The CAISO received comments on the topics discussed at the January 4, 2024 stakeholder call from the following:

The following are the CAISO's responses to the comments

1. Please provide your organizations comments on the approach to out-of-state wind resources.

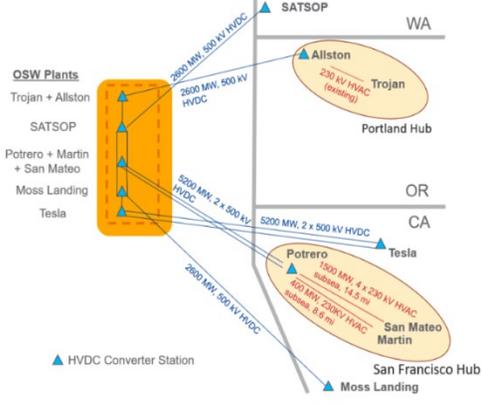
No	Submitting Organization	Comment Submitted	CAISO Response
		 <p>CEERT believes that a better approach to transmission planning for Northern California and Southern Oregon offshore wind development has been described in detail in a report issued by Pacific Northwest National Laboratory (PNNL) under contract with the Bureau of Ocean Energy Management [1]</p> <p>The PNNL study modeled three generation and transmission scenarios across two future representations of the Western Interconnection, including (1) 3.4 gigawatts of installed OSW capacity connected through a 2030 high voltage alternating current Radial Topology, (2) 16.3 GW of installed OSW capacity connected through a 2030+ high voltage direct current Radial Topology, and (3) 16.3 GW of installed OSW capacity connected through a 2030+ multi-terminal high voltage direct current Backbone Topology.</p> <p>CEERT encourages the CAISO staff to review this report and include a scenario in the 20-Year Transmission Outlook that includes the HVDC Backbone Topology. The approach used by PNNL assumes the delivery of energy through a networked system to Moss Landing, Potrero, Tesla, Allston and Satsop substations via seven HVDC cables. A schematic of this approach is copied below from the PNNL report</p>

No	Submitting Organization	Comment Submitted	CAISO Response
		 <p>Figure 14. Transmission expansion incurred by 2030+ MTDC Backbone Topology Graphic not to scale. Cable carrying capacities corresponding to maximum assumed technology limits.</p> <p>In addition to providing reliable access from North Coast offshore wind resources to California and the Pacific Northwest, the Backbone Topology approach improves system resiliency and the amount of deliverable capacity from the wind resources. CEERT understand that there will be issues related to cost allocation if this approach were to be pursued. Nonetheless, it will be valuable to model this approach on the downstream CAISO system.</p>	
2G	Fervo Energy	No comment	
2H	Gallatin Power Partners, LLC	No comment	
2I	Golden State Clean Energy	No comment	
2J	Invenergy	<p>In this update on the 20 Year Transmission Outlook, CAISO has maintained the same approach and planning numbers as the original presentation on August 16, 2023. Invenergy continues to believe that the CAISO should model additional offshore wind in the Central Coast. Generally, the CAISO should include 25 GW of offshore wind, in line with the California Energy Commission (CEC) Assembly Bill (AB) 525 planning goal of 25 GW of offshore wind capacity in California by 2045.[1] The CAISO should also study at least 7,000 MW of offshore wind on the Central Coast specifically.</p> <p>In the response to Invenergy's original comments on the 20 Year Outlook, the CAISO stated that it has pulled these numbers from the portfolios provided by the CEC and California Public Utilities</p>	<p>The 20-year outlook study is based on the 2045 portfolio provided by CPUC. Any future 20-year outlook will be based on an updated CPUC portfolio which may include different levels of resources at different location.</p>
